Docket No. 50-346

March 29, 1985

PLANNED MODIFICATION TO THE  
HIGH PRESSURE INJECTION SYSTEM

PLANNED CONFIGURATION FOR HPI PIPING INSIDE CONTAINMENT

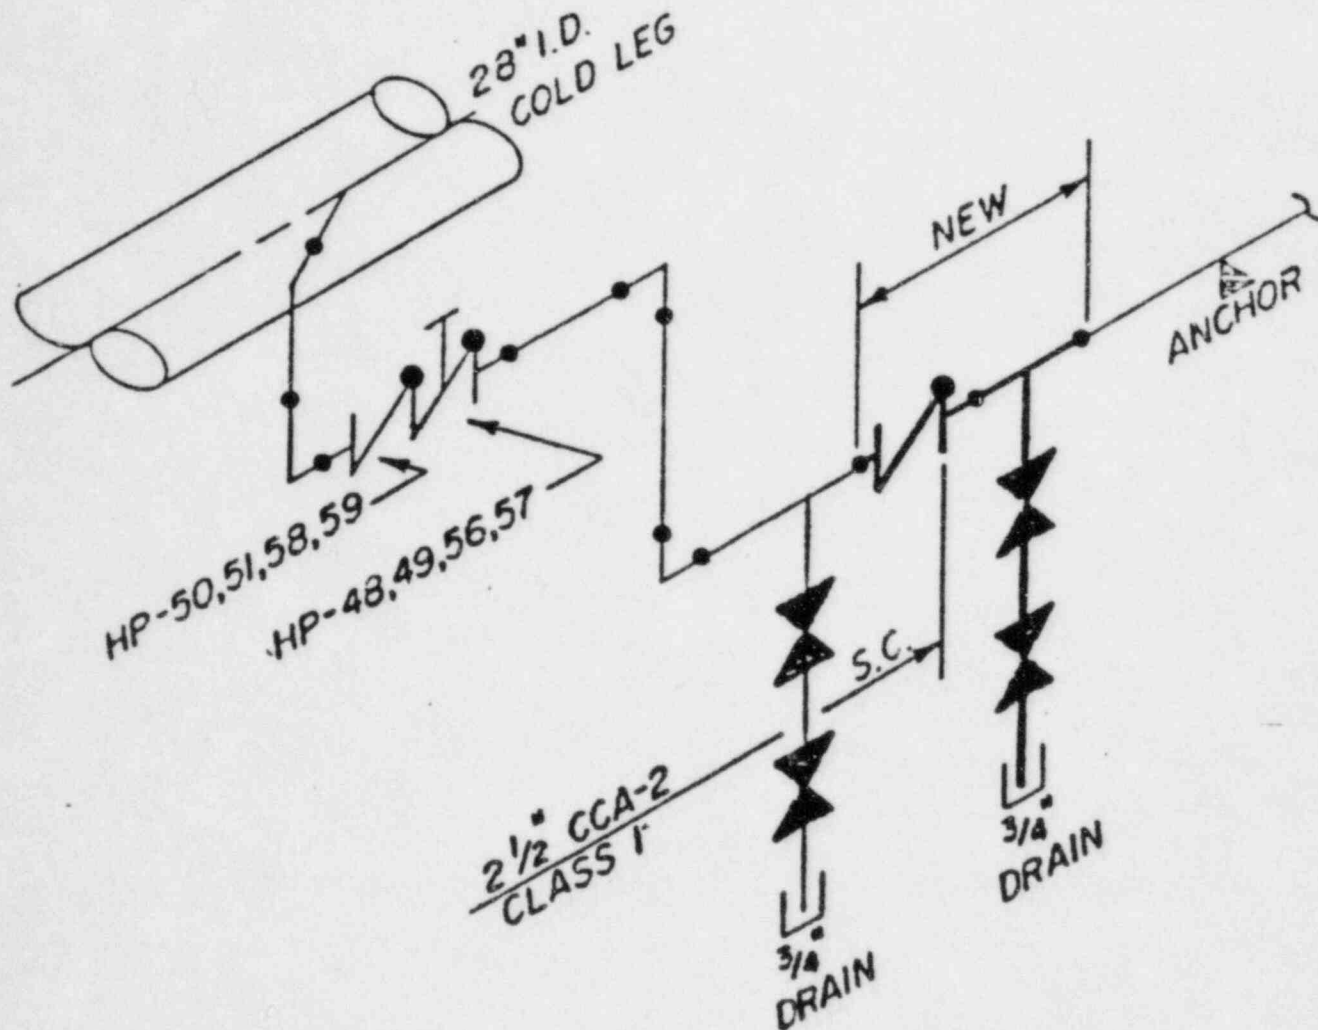
The system change includes adding a separate swing check valve upstream of the present back-to-back check valves with its own drain point available for leak monitoring. This configuration offers the following advantages to Toledo Edison:

1. Allows leak testing to be completed for the back-to-back check valves and the swing check valve on each line. The back-to-back check valves are presently considered one valve.
2. Maintains two valves in Class 1 piping as the reactor coolant system boundary.
3. Places the swing check valve up stream of the stop check valves (HP-48, 49, 56, 57), thereby separating the swing check valve from the reactor coolant system when the stop check valve is locked closed and a drain valve is opened. This will provide Station personnel the capability of maintaining the swing check valve without removing the reactor core and inserting reactor coolant system cold leg plugs during an outage.
4. Moves the swing check valve from adjacent to the reactor coolant system and cold legs, thereby changing radiation exposure to ALARA.

On a refueling outage frequency the valves will be tested for closure capability using leak detection methods to determine closure capability in accordance with Technical Specification 3.4.6.2.
